Subject: Tailing Disposal System  
Church Rock Uranium Project  
Job No. 74131-001 File No. 2.02.10

The following information and recommendations are provided in response to questions posed by the State of New Mexico, Environmental Improvement Agency with regard to the design and construction of the subject dam, as described in their letter to you, dated February 9, 1977:

# TAILINGS DISPOSAL DAM TYPICAL SECTION SCALE 1" = 50'

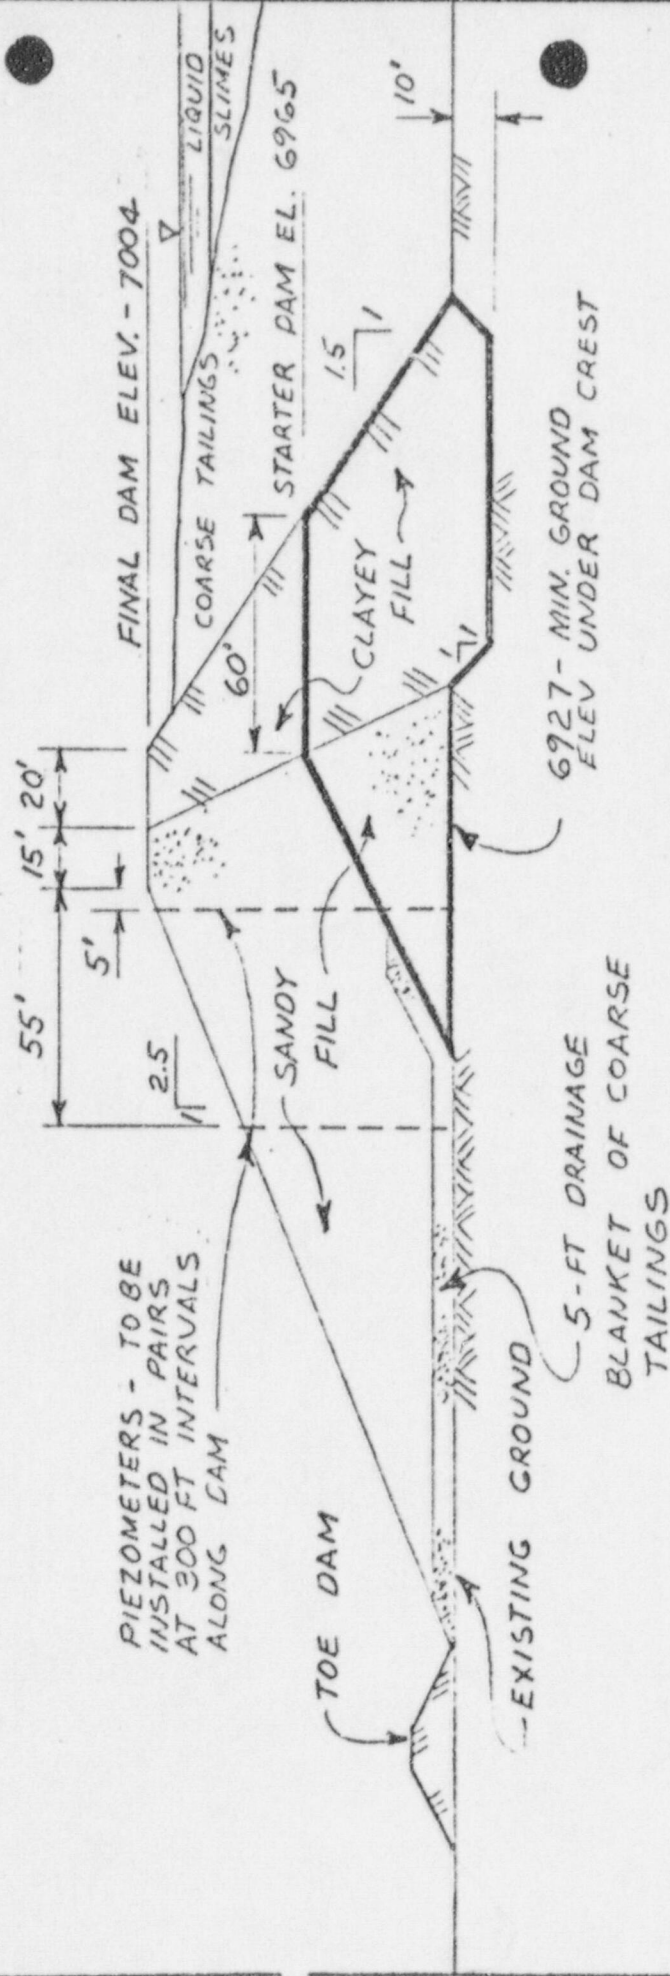
The present design is shown on the attached cross section sketch and consists of compacted local soils. Tailings material will not be used for construction of the dam except for a 5 ft. layer of drainage material which will be constructed from coarse tailings sand. Tailings material must be used because clean sand or gravel suitable for use in the drainage layer is not available in the area. The dam consists of two sections. The first section consists of a core of relatively impervious clay soil which is placed in the upstream face of the dam. Its function is to minimize the amount of seepage through the dam. The second section consists of sandy soil placed in the downstream face. Its function is to keep the downstream side of the dam dry by allowing the small amount of seepage which passes through the core to drop quickly down into the drainage layer. The structural stability of the dam is

assured by keeping the downstream portion of the dam dry. Diagrams showing the seepage flow path are included in the February, 1976 report.

Design of the dam also includes an earth embankment built from clay soils and located at the toe of the main dam. The toe dam provides a positive separation between the Pipeline Canyon stream and the tailings pond.
